City of Miami Beach
Last Completed Item Reviews Across All Submittals

Permit Type: Building - Commercial **Work Class:** Alteration (w/o Phased) **Application Date:** 05/22/2020 **Status:** Approved
Address: 235 WASHINGTON AVE **Permit:** BC2013662

Re: Response to City Comments.

Sobe Hostel
235 Washington Ave.
Miami Beach, Florida

Date	JUNE 08, 2020	Sheet No.
Scale	AS INDICATED	FP101
Project	1967

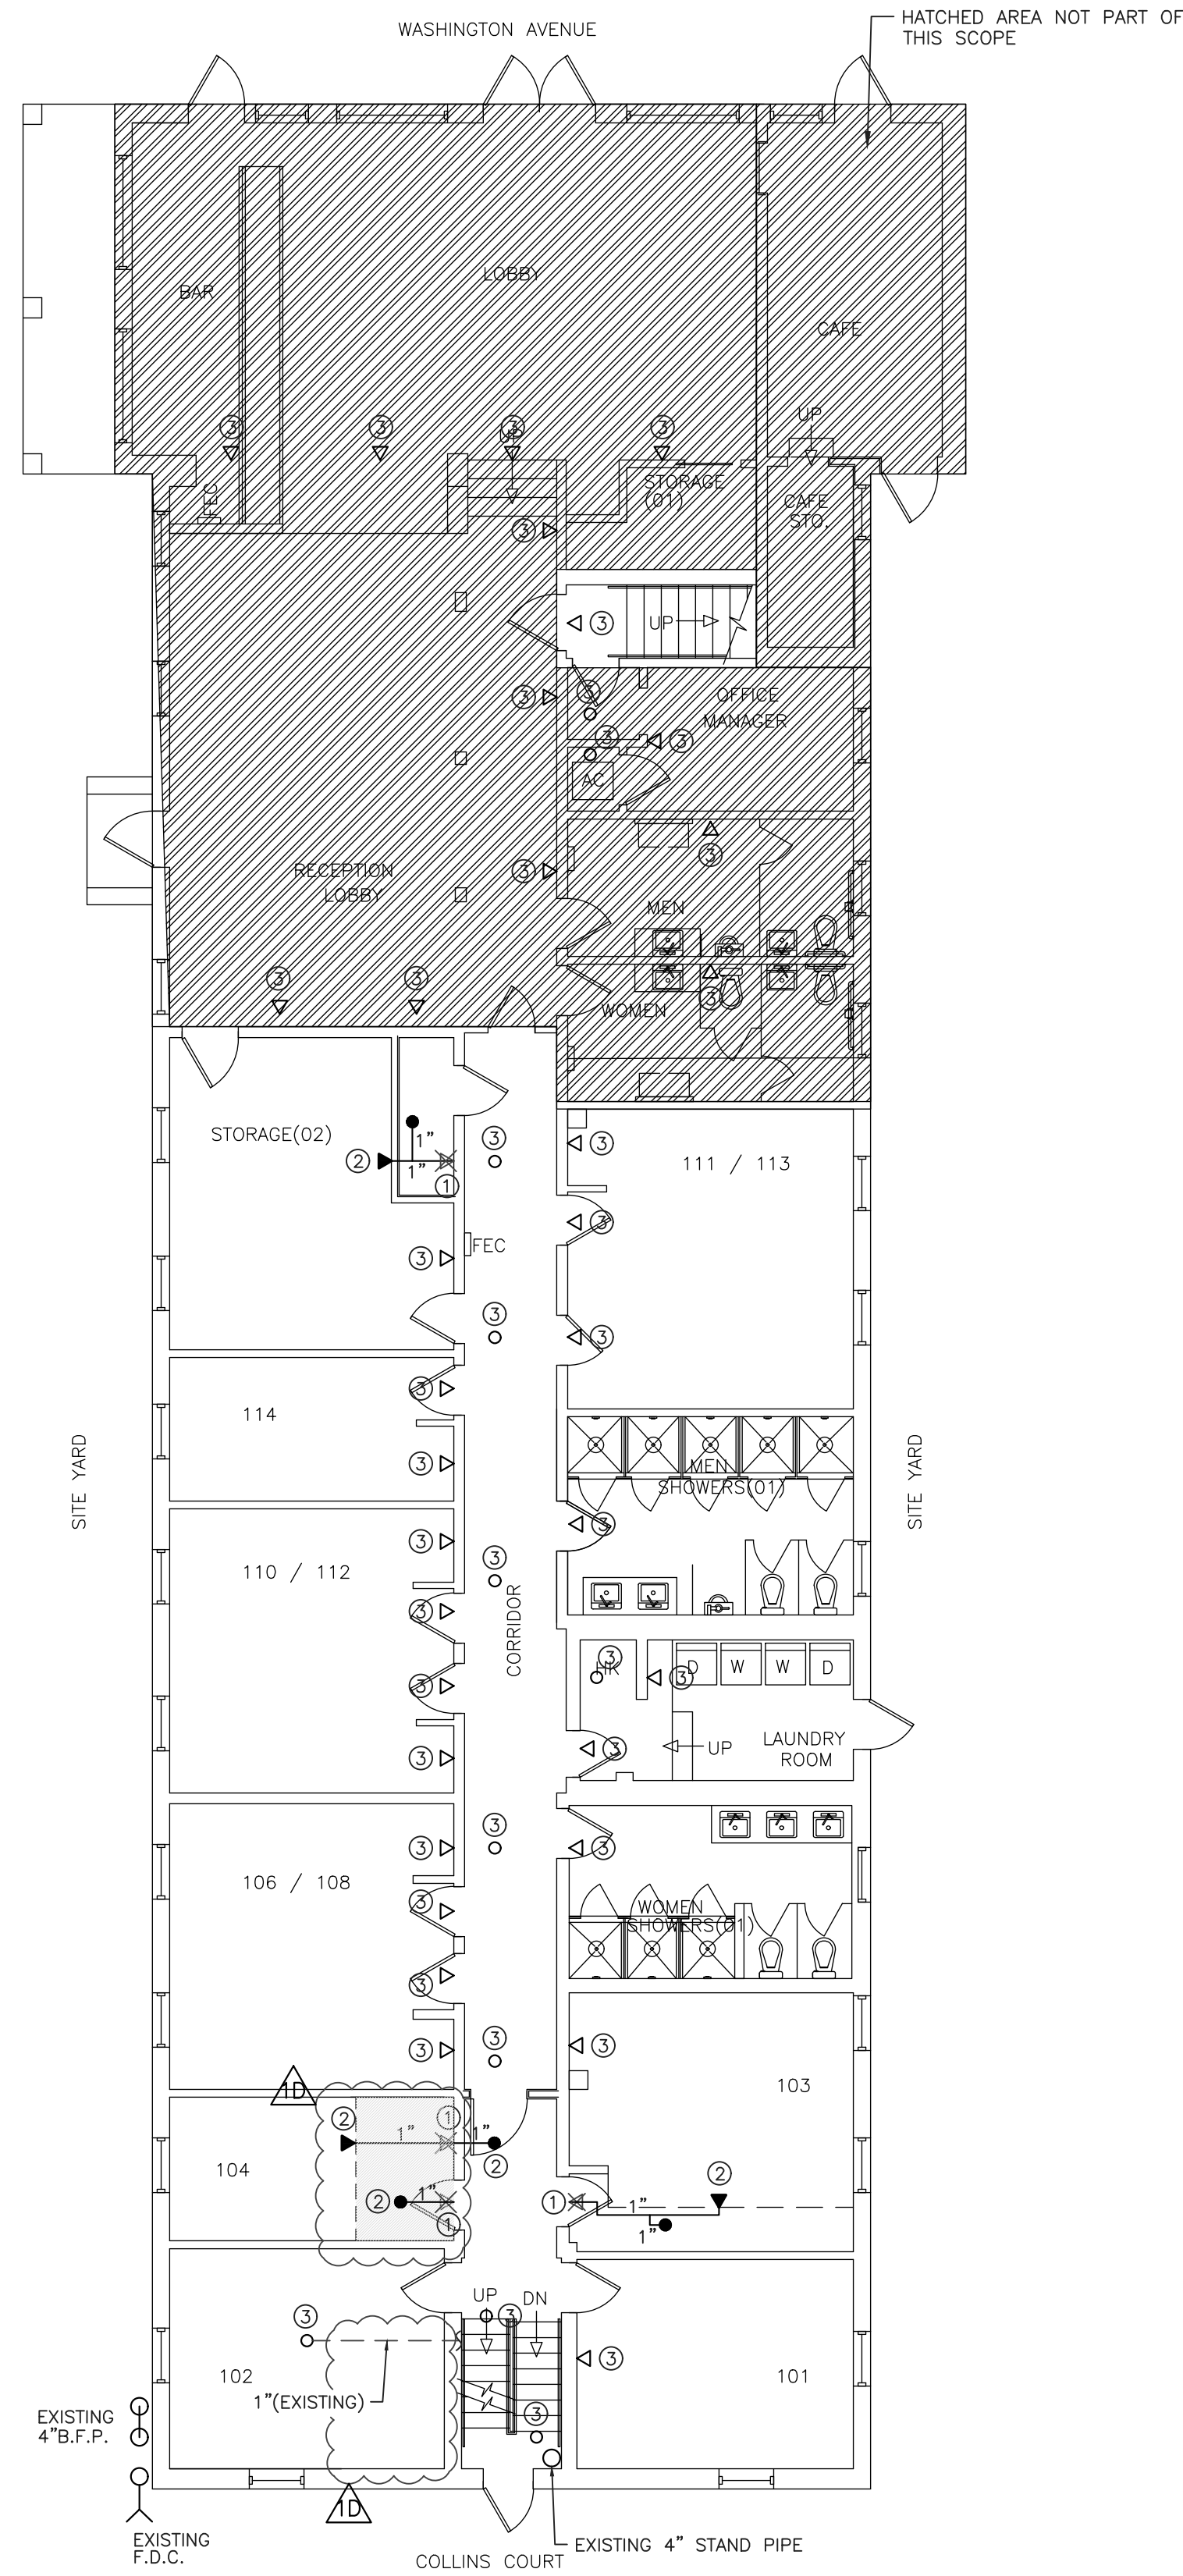
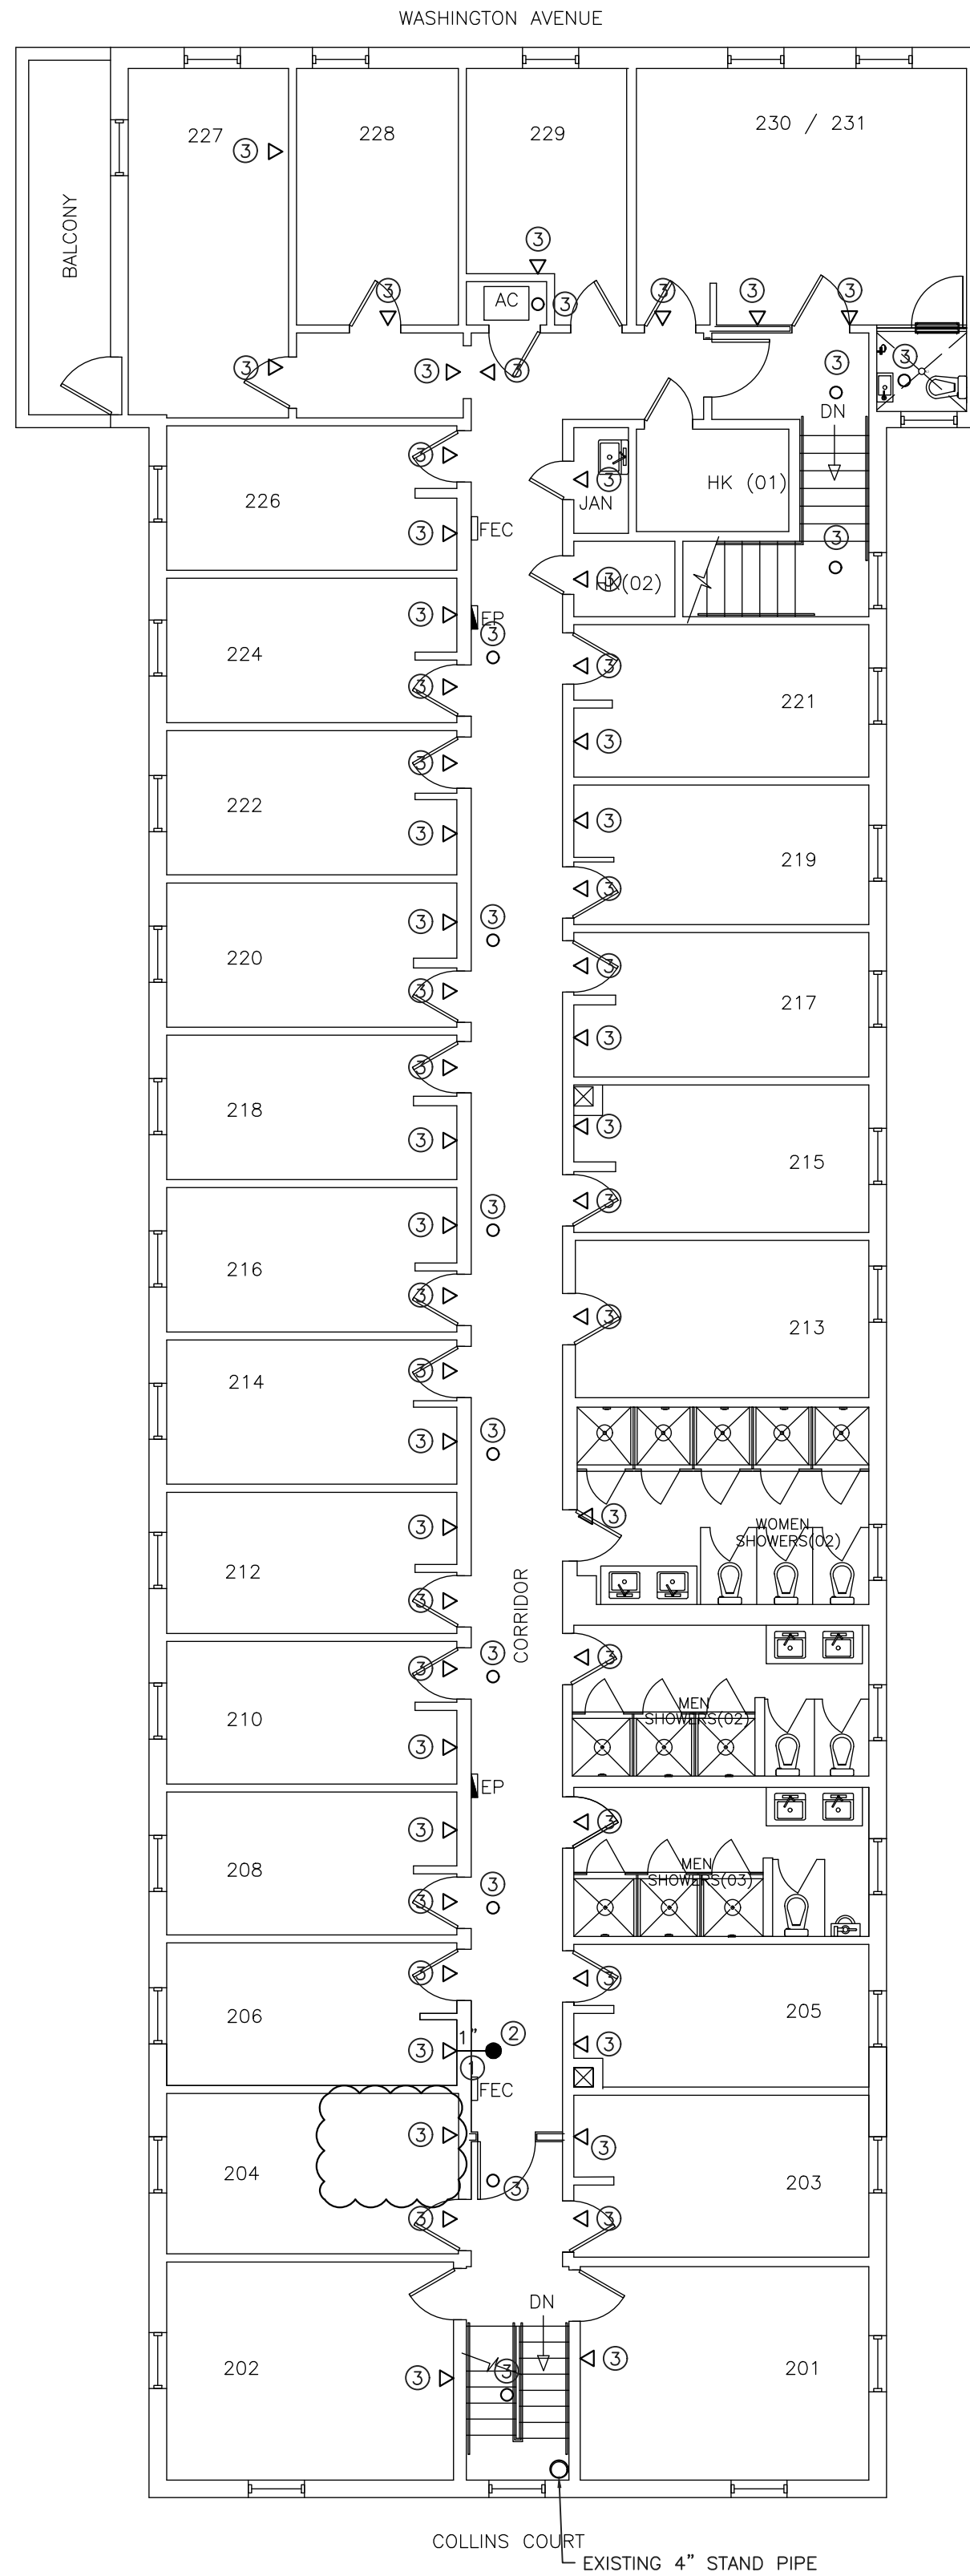
1. Plans stated building is sprinklered, but did not provide the set to verify scope of work did not affect original approved design for the building

KKAID Response: Refer to sheets FP101 and FP201

Date	JUNE. 08, 2020	Sheet No.
Scale	AS INDICATED	A1.00
Project	1967

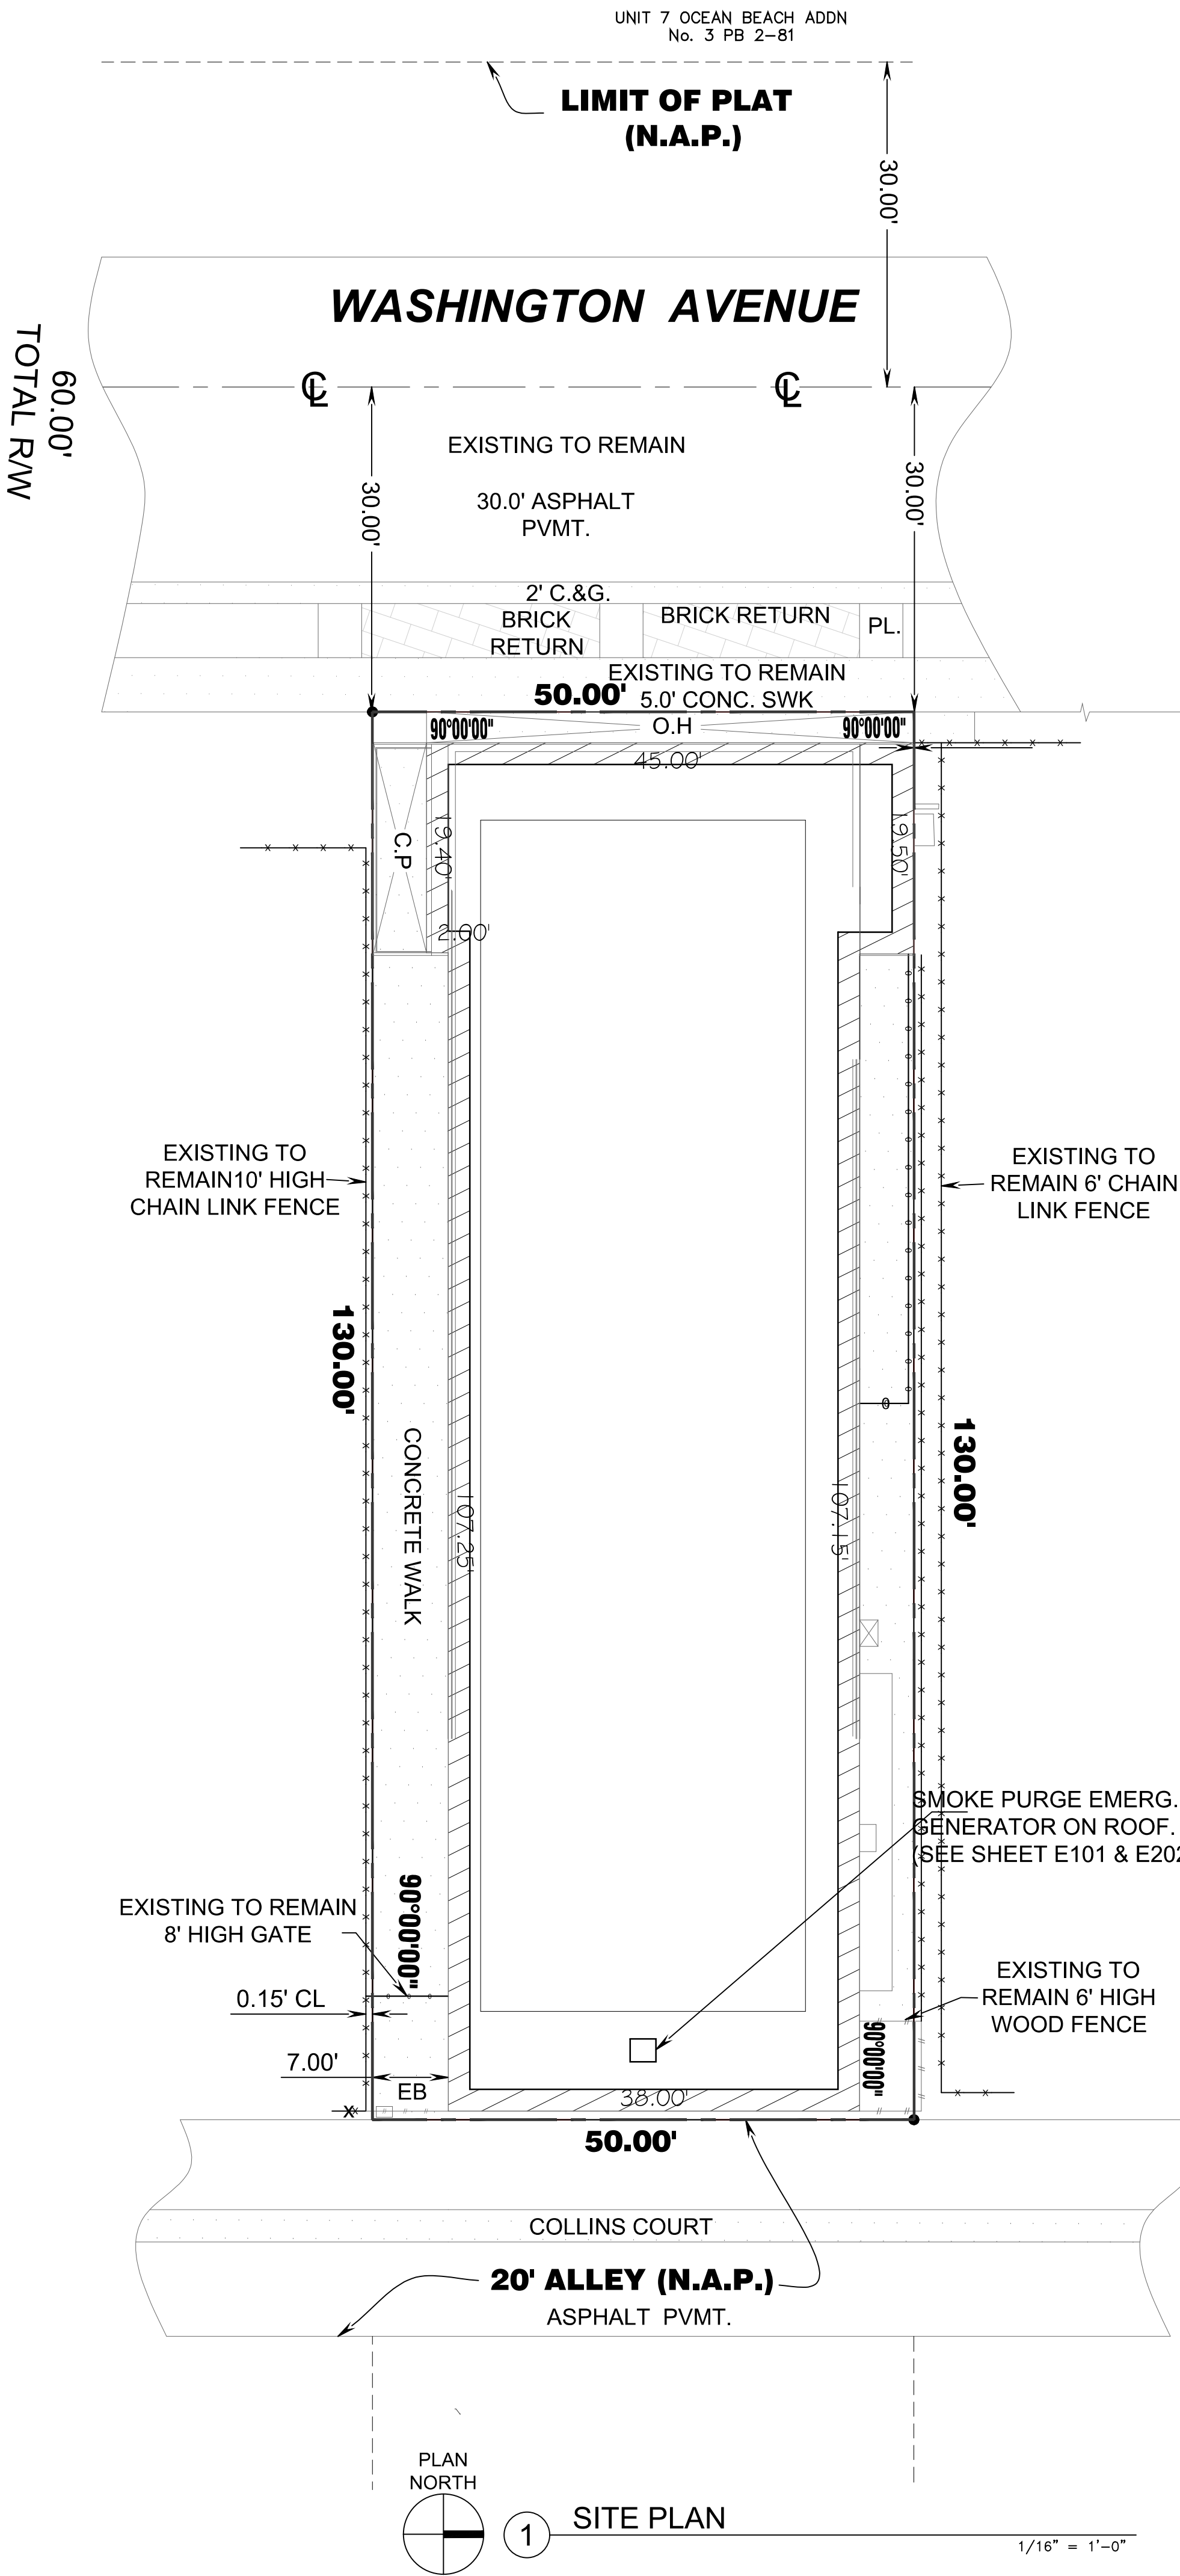
1. The notes for interior finishes refer to chap. 31, this is for existing apartment buildings, this is a hotel, revise all interior specifications throughout all sheets to reflect hotel requirements

KKAID Response: Reference changed to Chapter 29 – Existing Hotels and Dormitories
